SIGAR 18-09 Inspection Report

**Afghan Ministry of Defense Headquarters Security
and Support Brigade: Facility Construction
Generally Met Contract Requirements, but Three
Safety-Related Concerns Need to Be Addressed**

Photo 1 - On-Off Disconnect Switch for the Heater Installed Above an Ablution Washing Station

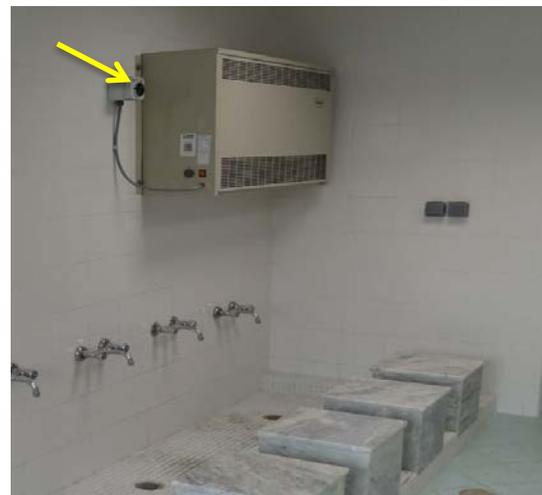
During our February 6, 2016, site visit, we found three electric heaters in the administration/barrack building that Gilbane Federal installed above the ablution washing stations.⁹ Our review of the as-built drawings showed that the electric heaters were installed in the location specified in the drawings.

AFCEC indicated that the installed electric heaters above the ablution washing station were acceptable because the design required ground fault circuit interrupter (GFCI) connections for the heaters in this wet area.¹⁰ However, we found that Gilbane Federal installed electric heaters with an on-off disconnect switch, instead of the required GFCI connection (see yellow arrow in photo 1). GFCI connections would protect people from severe or fatal electric shock if they operated the heater with wet hands or touched a heater with a ground fault, but the installed on-off disconnect switches would not.

that the HEPOL disconnect switches had GFCI safety features. Because the electric heater controls and disconnects are within reach of people with wet hands, people could be shocked or electrocuted if they touch a faulty heater with no GFCI device to stop the accidental flow of electricity through their wet hands and body. In its comments on a draft of this report, AFCEC stated that the heaters’ installation is consistent with the governing code. However, without GFCI protection, the electric heaters with disconnect switches in the ablution areas present a safety hazard to personnel there.

- 1. Develop an accurate set of as-built drawings for all systems that includes the locations of the electric heaters without GFCI protection, the oversized circuit breakers, and the exposed hot water pipes; provide the updated as-built drawings to the MOD HSSB facility managers; and inform the facility managers of the potential risks to ANA personnel.**
